# GENERAL ELECTRIC

MFN 170-81  
JNF 24-81

SUBJECT: SRV POOL DYNAMIC LOADS

Enclosed are GE's responses to the NRC questions on the SRV Pool dynamic loads in Mr. Kniel's May 21, 1981 letter. These responses will be used as the basis for the pending GESSAR II amendment. Only minor editorial changes are expected; however, there will be no technical differences between these responses and the formal responses in the amendment.

Figure 3BA.1(A)-1 Shell Residual (VAAQ Omitted) and Effect of VAAQ Term on Prediction

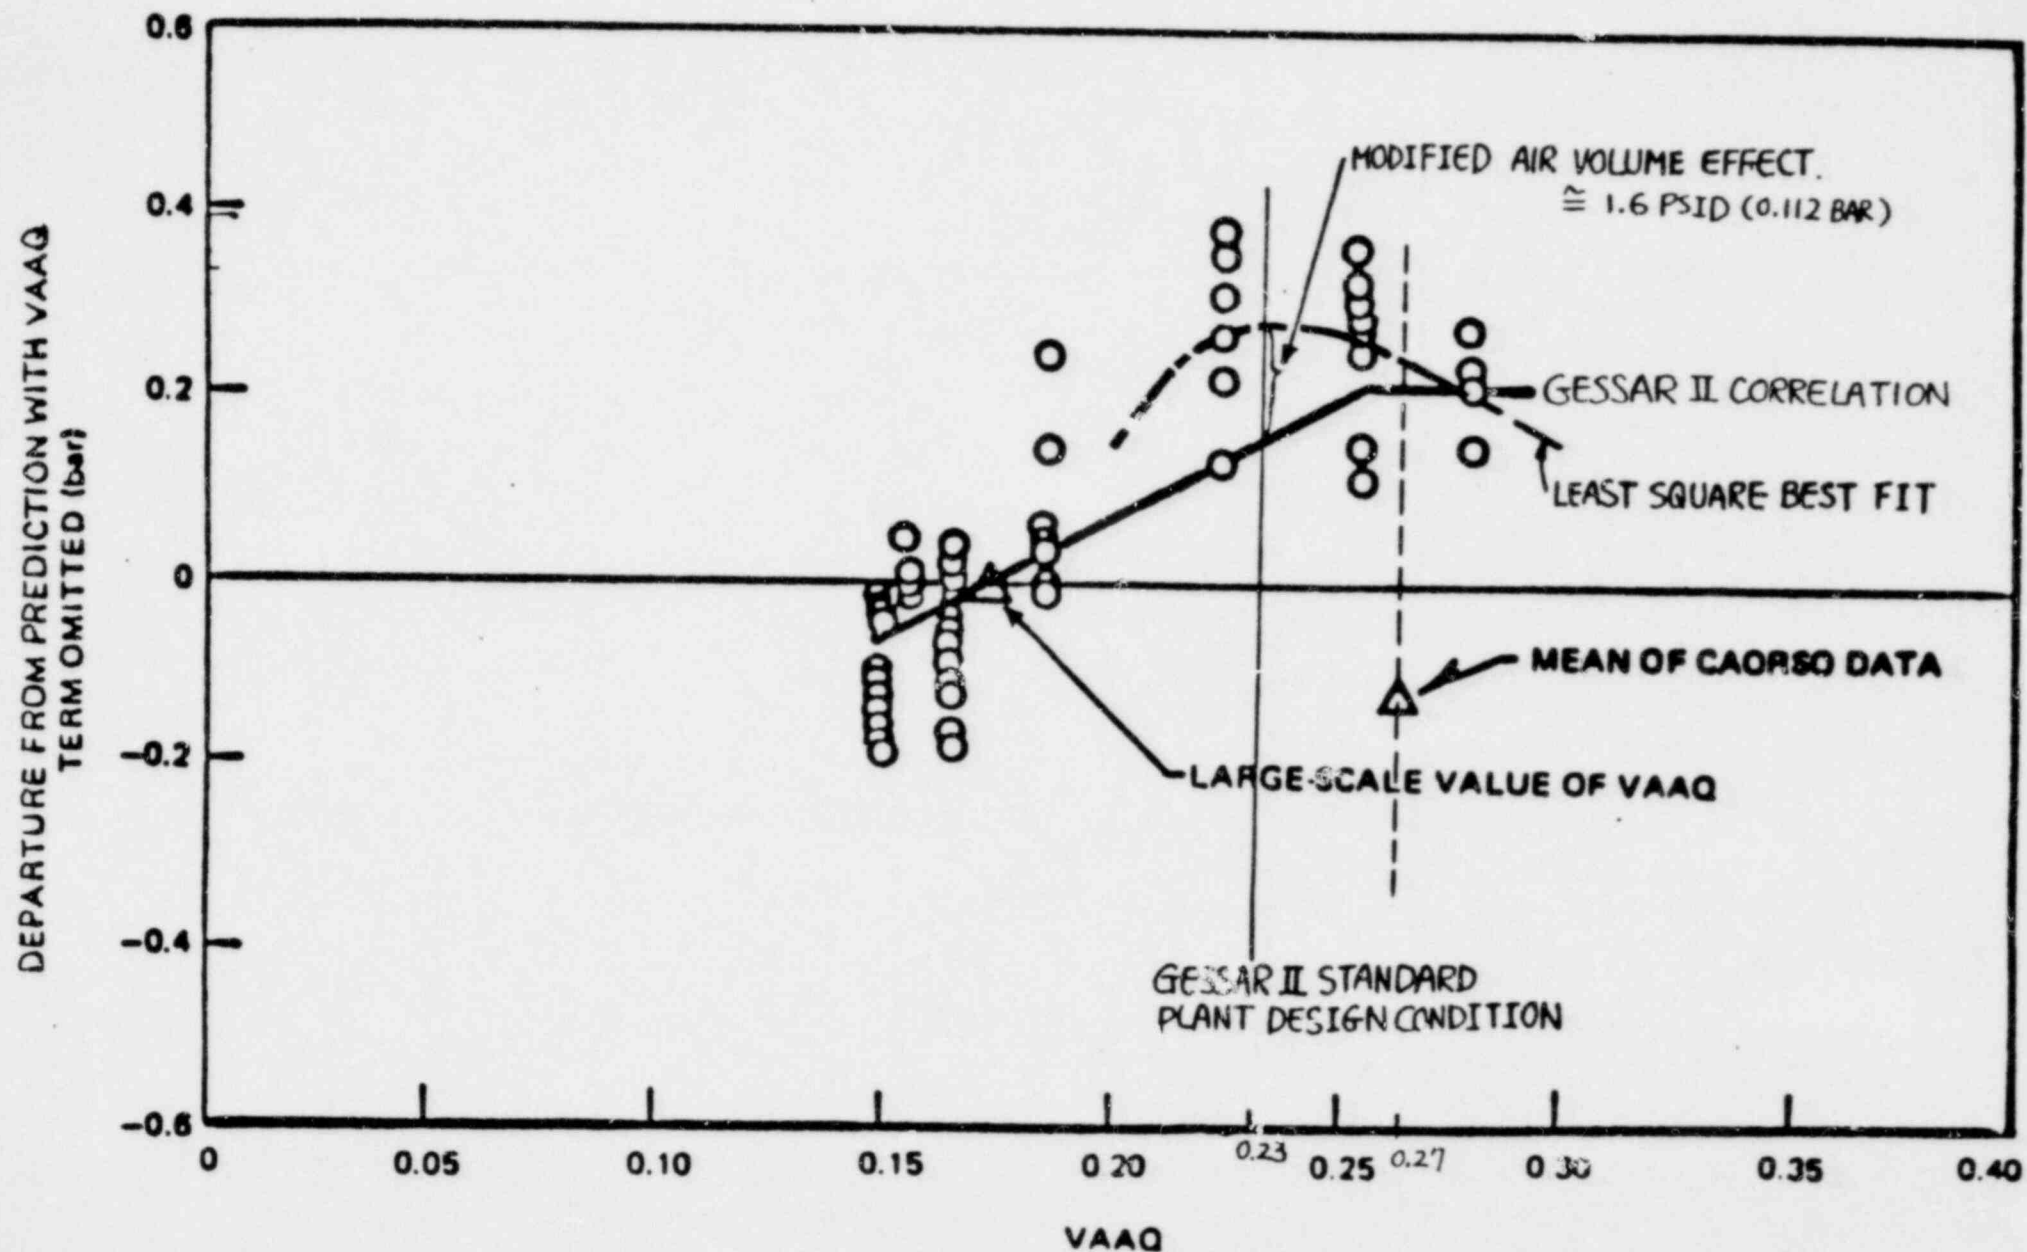
To illustrate this factor, consider the shape of the air volume term of the prediction equation as given in Figure 3BA-65 of GESSAR II. The Caorso air volume/quencher area value (VAAQ), as given in Appendix C of Reference 1, is sufficiently large to place it in the plateau region where a constant value is used for the VAAQ term of the prediction equation. The constant value is used to conservatively bound the VAAQ contribution to the maximum positive pressure in a region where it is known to decrease asymptotically toward zero. Since the VAAQ term contributes approximately 37% to the magnitude of MPP at Caorso plant conditions, we believe that this conservatism is primarily responsible for the high Caorso prediction values.

However, the standard Mark III 238 plant VAAQ value places it in the ramp portion of the curve where the highest values of positive pressure were observed. As a consequence, no conservatism of the type discussed above is anticipated and therefore the use of a multiplication factor appears not to be justified. In order to continue our review of the quencher methodology, the following items are requested:

Provide any additional justification for the use of the multiplication factor for Mark III plants.

The justification for the use of the multiplication factor for the Mark III Standard Plant is provided with the comparisons of the Caorso test data to the GESSAR II safety/relief valve (SRV) load definition. The applicable Caorso test data used in this comparison includes both phase I and phase II tests of valves A, E, and U. The measured maximum and minimum (negative) pressure amplitudes of these tests were taken from the recordings of pressure sensors P19, P13, P15, P50, P51, and P57.

FIGURE 3BA.1(CB)-1 MPP OBSERVED vs. PREDICTED VALUES.

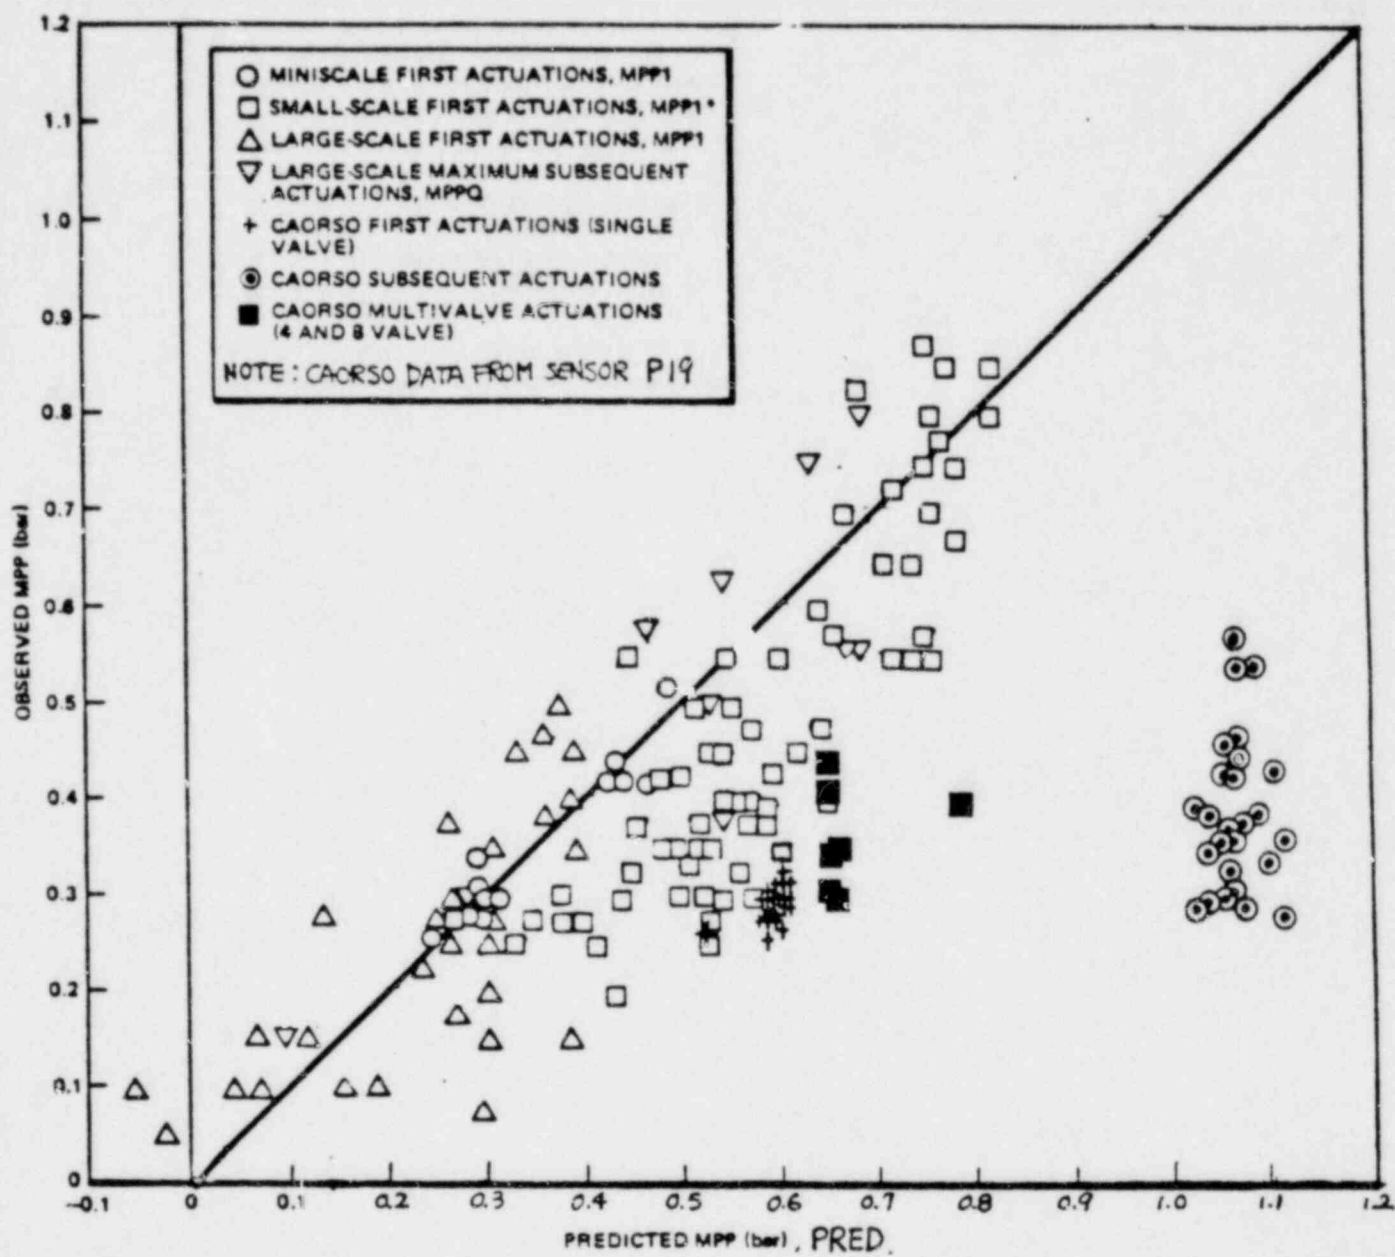
Identify which Caorso data points were used in Figure 3BA-58 (i.e., test and transducer numbers) and tabulate the various parameters used to generate the prediction values.

The measured and predicted Caorso positive pressure data were incorrectly plotted in Figure 3B-58. Figure 3BA.1(B)-1 represents the correct Caorso data and now includes all applicable phase I and II data. The relationship presented in Table 3BA-21 was used to predict the Caorso test pressures. The predicted pressures and the various parameters used to generate the predicted values are summarized in Table 3BA.1(B)-1. A tabulation of the measured and predicted Caorso positive pressures is presented in Table 3BA.1(B)-2.

FIGURE 3BA.2(A)-1 COMPARISON OF  $\overset{P_d}{\downarrow}$  PREDICTION vs. CAORSO DATA FOR MINIMUM PRESSURE.

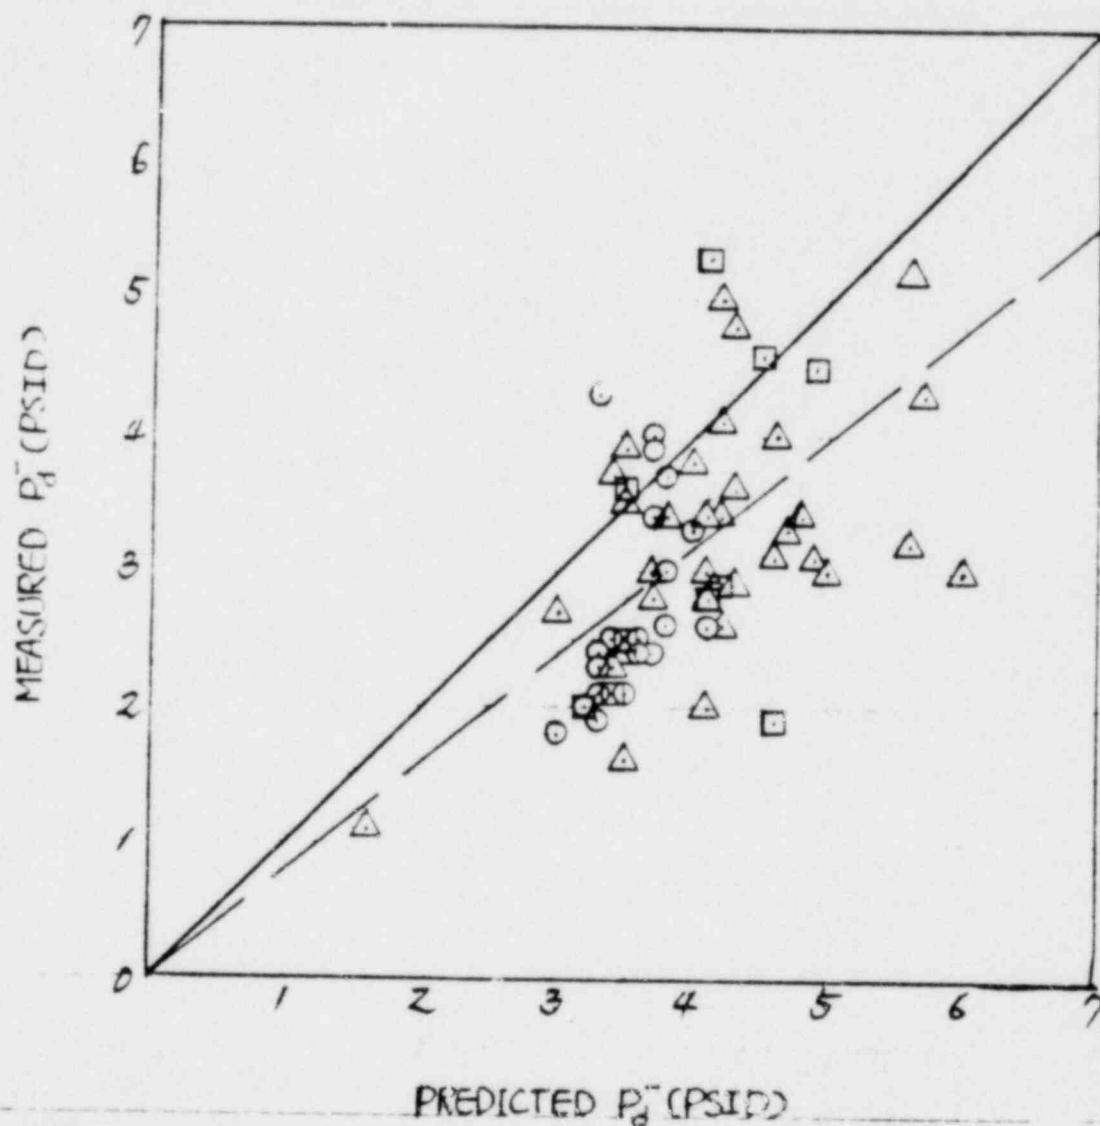
It is stated in Section 3BA.12.4.2 that the Caorso tests also confirmed the comparison which utilized the small-scale and large-scale test data as illustrated in Figure 3BA-53, i.e., a comparison of minimum absolute pressures predicted by Equations 3BA-12 and the actual measured values. Provide a similar figure using the Caorso data along with a tabulation of the measured values. Include, as part of the tabulation, the test number and transducer number of the various pressure measures used in the comparison.

The requested figure and tabulations are provided in Figure 3BA.2(A)-1 and Table 3BA.2(A)-1. Equation 3BA-12 was used to determine the predicted minimum pressure of Figure 3BA.2(A)-1. This figure confirms the GESSAR II absolute minimum pressure prediction of equation 3BA-12, and it also shows that the GESSAR II correlation provides a margin of approximately 20% based on a best fit of the prediction of the Caorso data.

FIGURE 3BA.2(B) - 1 COMPARISON OF CAORSO TEST ADJUSTED TO STANDARD PLANT DESIGN CONDITIONS AND GESSAR II DESIGN VALUES.

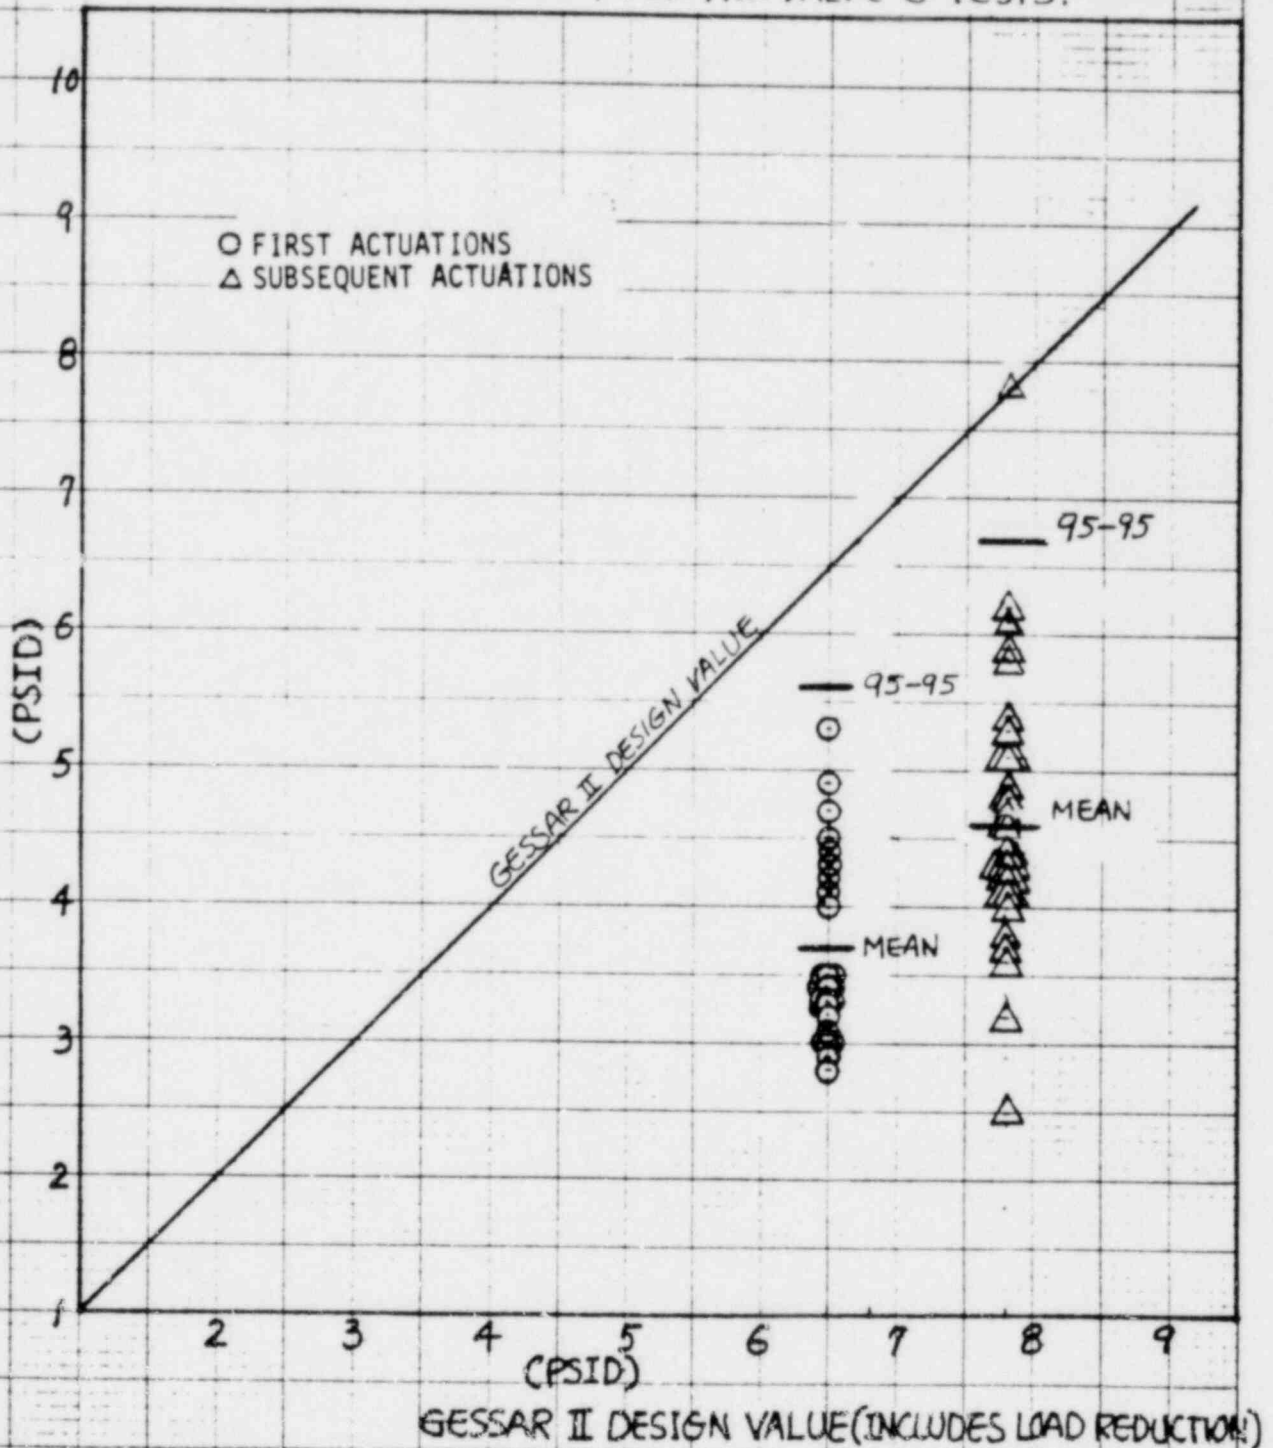
Section 3BA.12.5.14 presents the equation for the maximum negative pressure design value (MNPDV). This equation is based on the correlation of the positive and negative pressure peaks as discussed above. However, an additional term (FACT), which is based on the Caorso data, has been added in the denominator of the equation. Provide the justification and rationale behind the addition of this term which reduces the magnitude of the design value.

In Figures 3BA.2(B)-1 through 3BA.2(B)-3 the adjusted Caorso maximum negative (minimum) pressures are plotted versus the current GESSAR II design value obtained with Equation (1). The adjusted pressure data were obtained with Equation (2) below using the GESSAR II equation 3BA-12 and the same adjustment procedure as for positive pressures:

The comparisons shown in these figures reveals that both the maximum and 95-95 limits of the adjusted Caroso data are bounded by the GESSAR II design value. Therefore, the use of the multiplication factor is justified.
